VERMONT YANKEE NUCLEAR POWER CORPORATION

FVY 84-95

Subject: Supplemental Information Regarding the Vermont Yankee 1984
Refuel Outage Augmented In-Service Inspection Program

VIEW PIPE

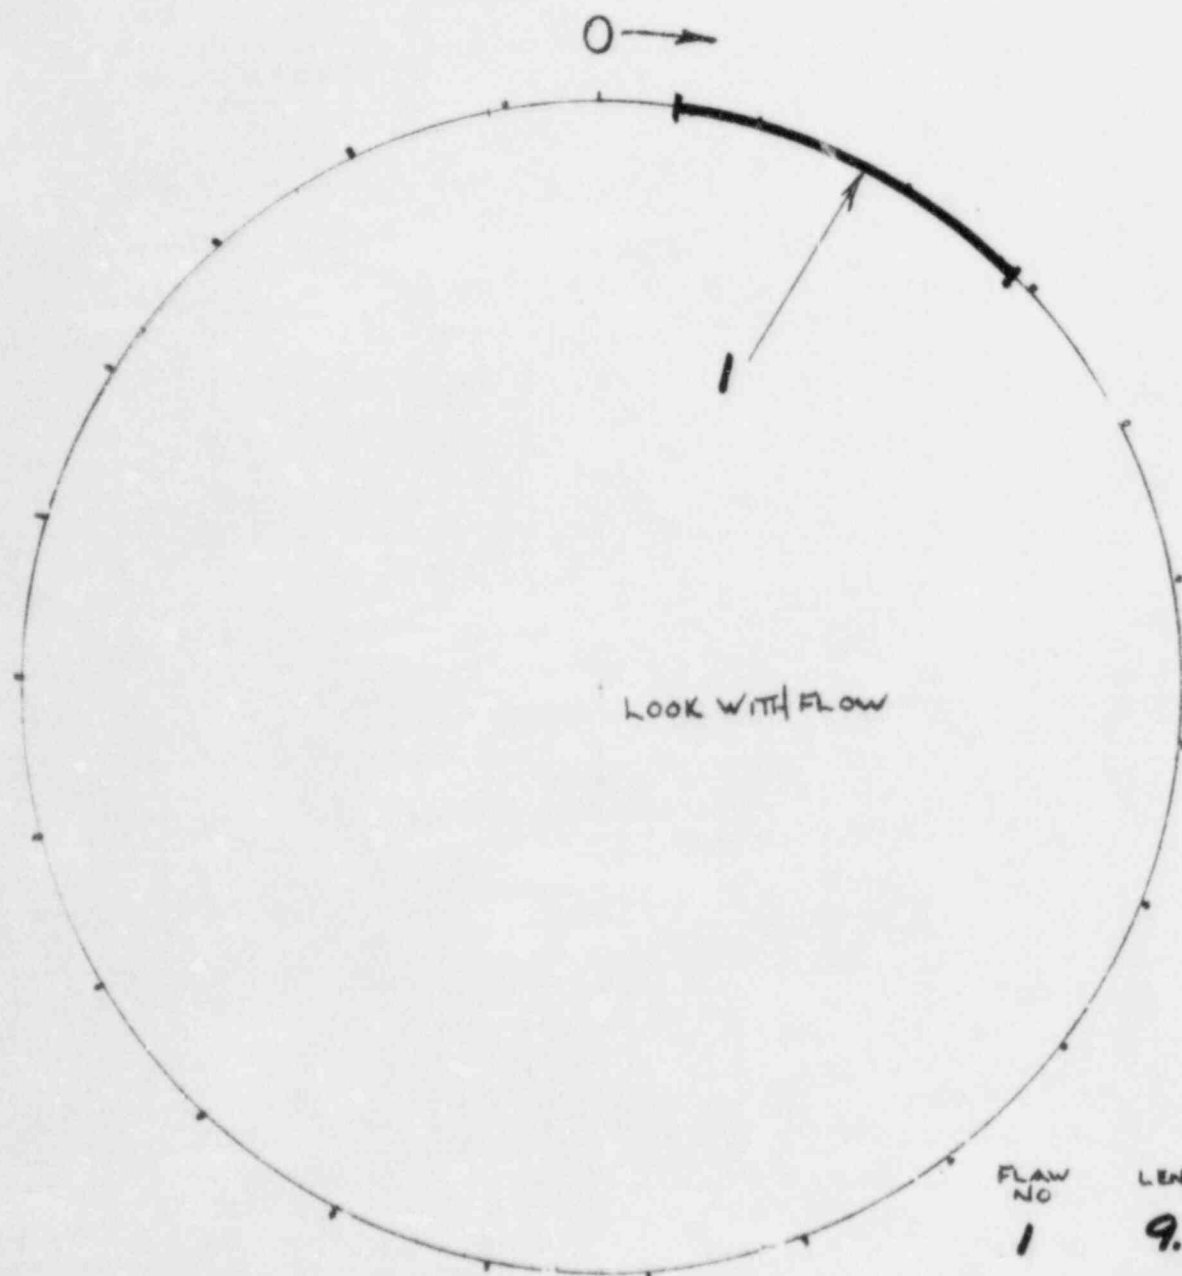
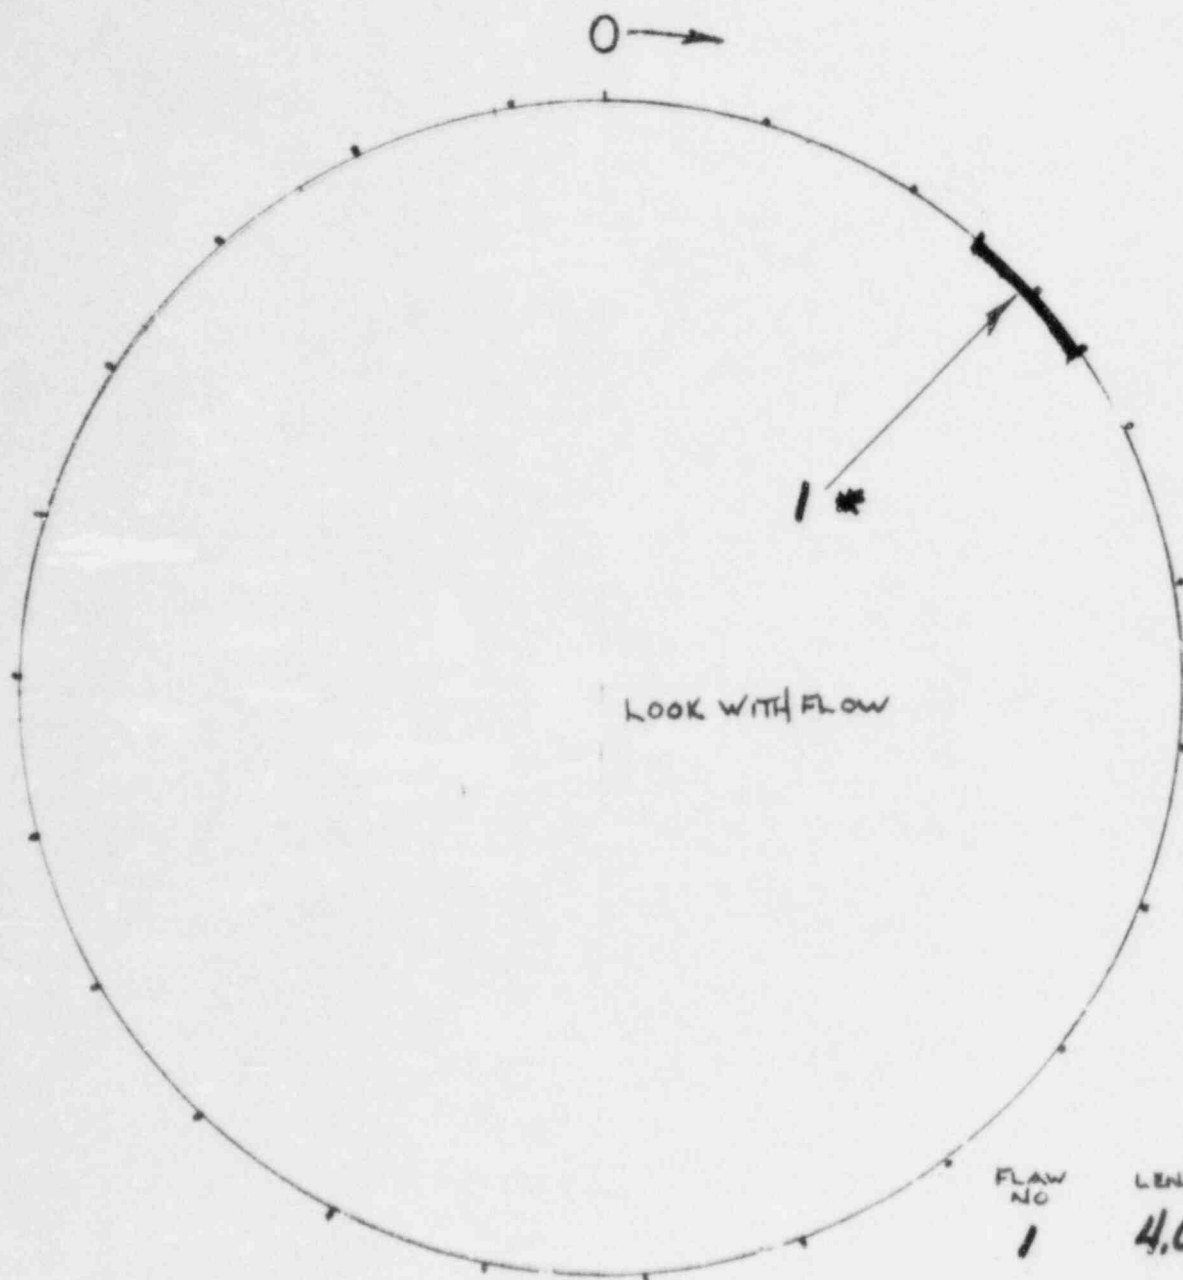
4. Table VIII of our Final Report provides a summary of weld joint flaws for 1983. Your Staff requested that we submit weld flaw diagrams for 1983 similar to those provided in Table IX of our Final Report.

Your Staff also requested that we describe the criteria for how we determined the flaw lengths for 1983. This information is provided in Attachment A to our Final Report; however, additional clarification was requested.

The requested weld joint flaw diagrams for 1983 are attached to this letter. These diagrams are supplements of Table VIII of our Final Report.

It should be noted that the 1983 flaw summary diagrams are reconstructions called "flaws" from 1983 examinations. In comparing the 1983 flaw diagram to the 1984 diagram, it must be recognized that the 0° points are not exact. In addition, neither the 1983 or the 1984 summary diagrams contain all recorded indications, but rather, they represent the end results of the detection and discrimination processes.

In 1983, the procedural requirements (which served as the basis for the I&E Bulletin 83-02 Qualification) were to carry the linear extent of an indication to the point where its amplitude dropped to one-half the maximum amplitude. In instances where indications continued for any distance at less than one-half maximum amplitude, the indication was continued over the full extent until the indication definitively dropped.
